CITY of NOVI CITY COUNCIL

Agenda Item 3
January 10, 2011

SUBJECT: Consideration of the request of Walmart Stores East LP, Inc. for Special Land Use Permit and Preliminary Site Plan approval. The subject property is located in Section 14, at the northwest corner of Eleven Mile Road and Town Center Drive, in the TC, Town Center District. The subject property is approximately 12.8 acres and the applicant is proposing to demolish portions of the Novi Town Center and construct an approximately 149,000 square foot Walmart store to include an open air area for the sale of plant material and garden supplies.

REVISED LAYOUT PLAN – UPDATED PLANNING REVIEW MEMO

LAYOUT PLAN

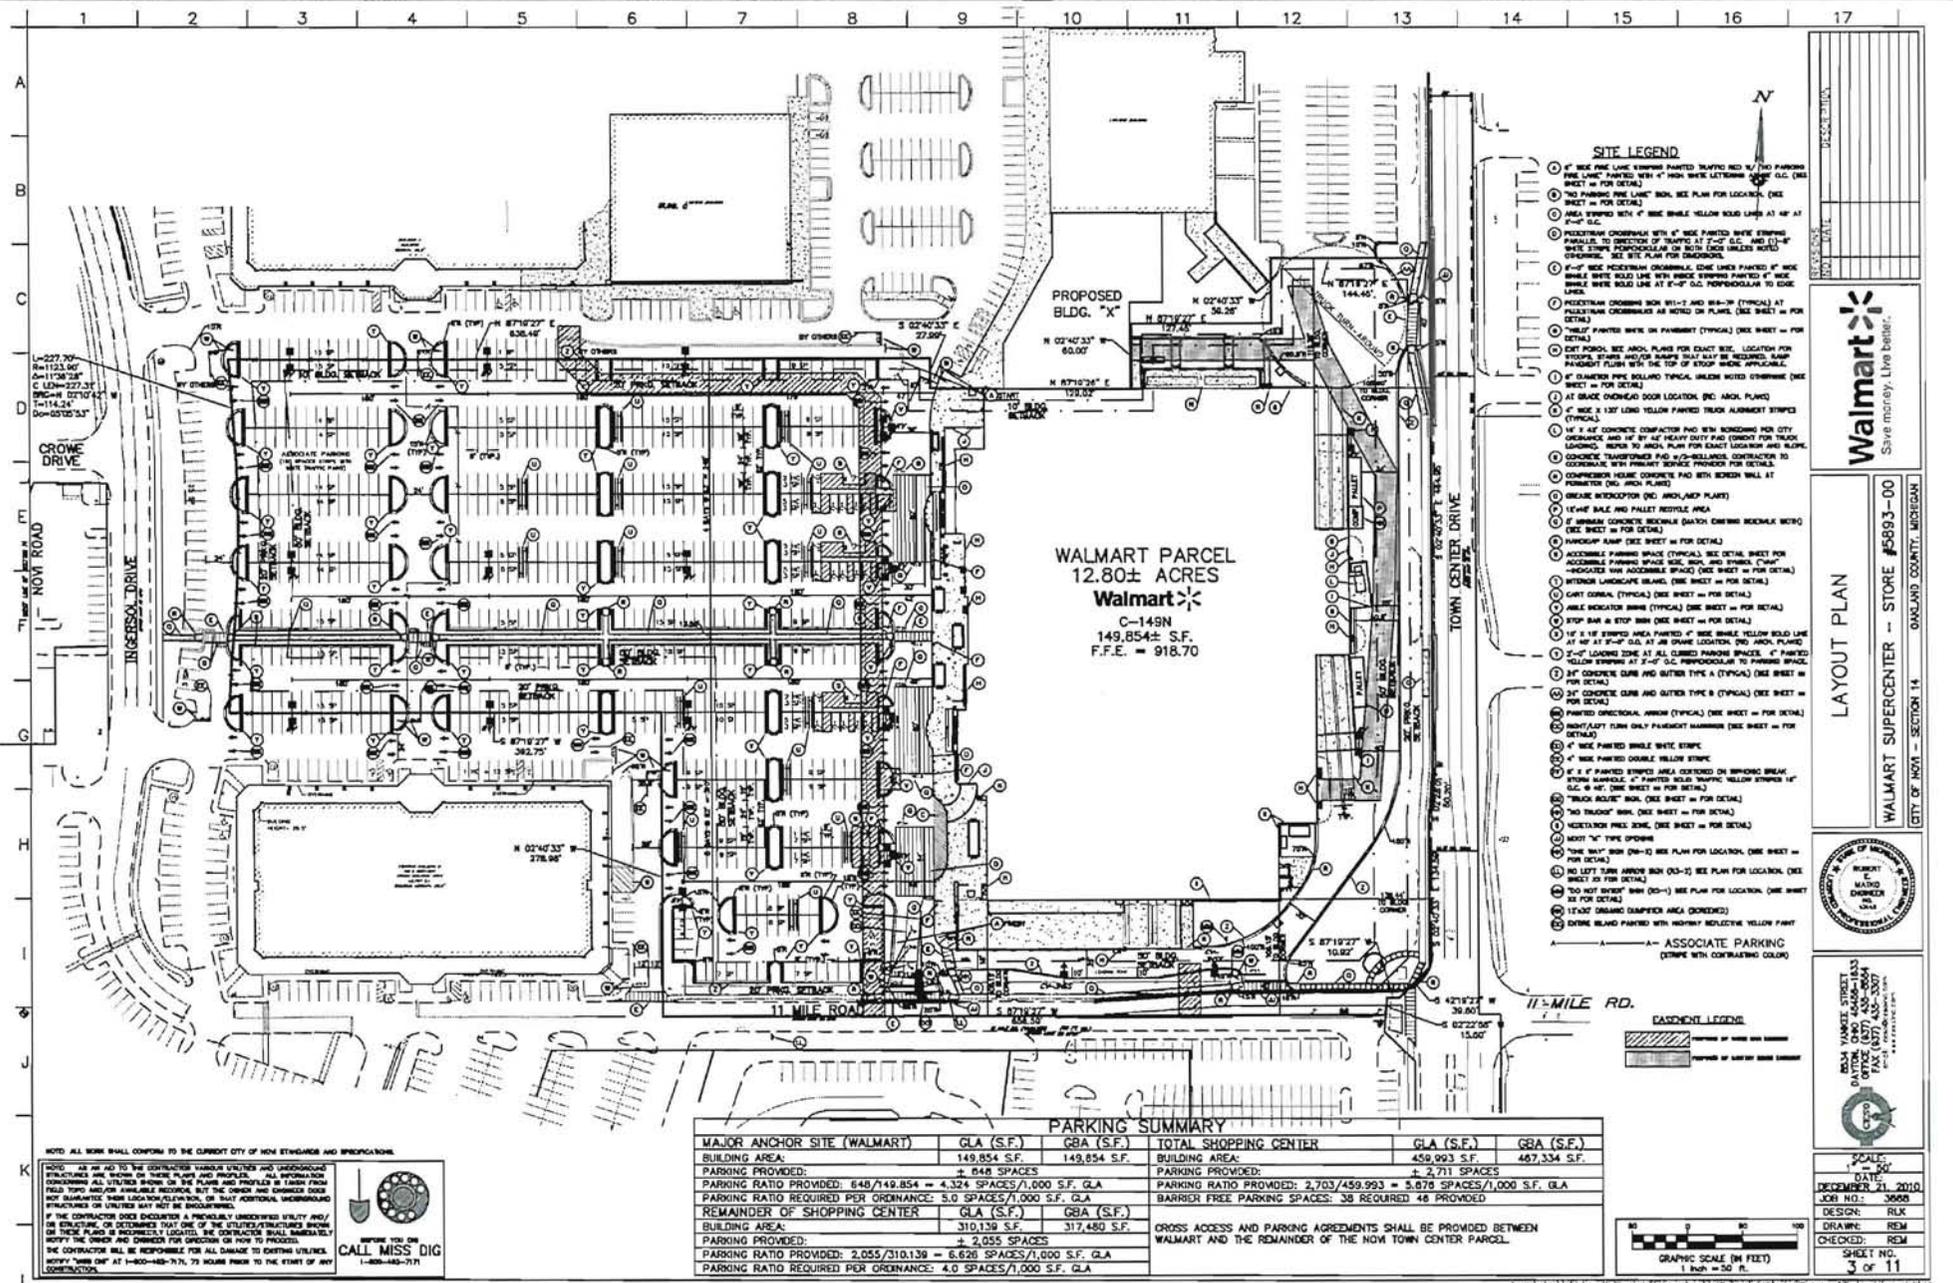
1. Fire lanes shall be designated and properly marked in accordance with city ordinance. Sheet 3 of 12 indicates fire lanes with pavement markings. However, 'No Parking' signs are not shown on the plan. The Legend on page 3 of 12 indicates note 'B' as No Parking Fire Lane signs, however, there are no tags 'B' on the plans. Fire lanes shall be designated on the west, south, and east sides of the building in accordance with the fire prevention code and shall be designated with signs in accordance with this ordinance.

Figure 2. Birchler Arroyo Pre-Application Conceptual Design for Portion of Site Near Southwest Corner of Proposed Wal-Mart Store

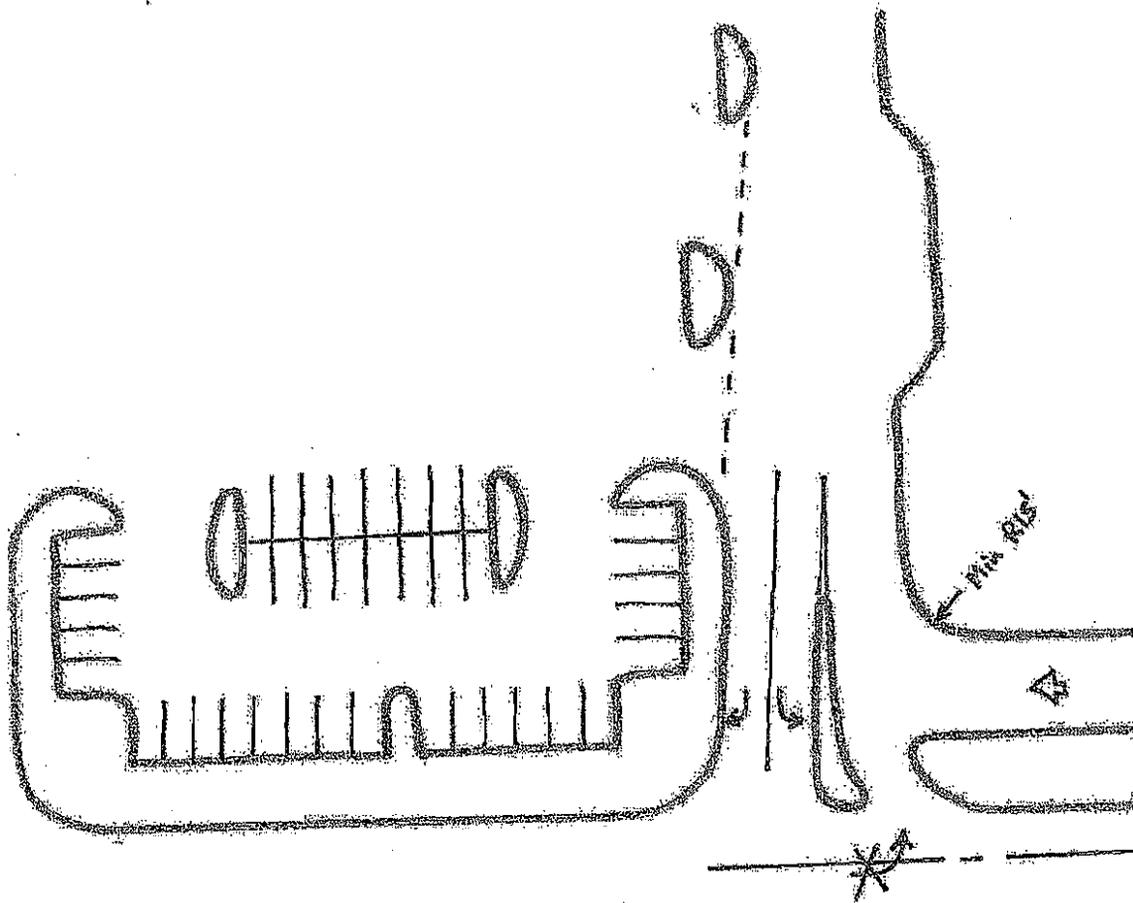
7. The pre-application site plan showed the proposed access drive near the southwest corner of the Wal-Mart store as a right-in/right-out driveway, with a very short throat (the first parking aisle north of 11 Mile would have been directly accessible). We saw no need for prohibiting exiting left turns here if the throat is lengthened as now proposed; however, entering left turns still appeared appropriate given the lack of a left-turn lane on this section of 11 Mile. Our proposed redesign of this area of the site is illustrated in Figure 2 (attached).
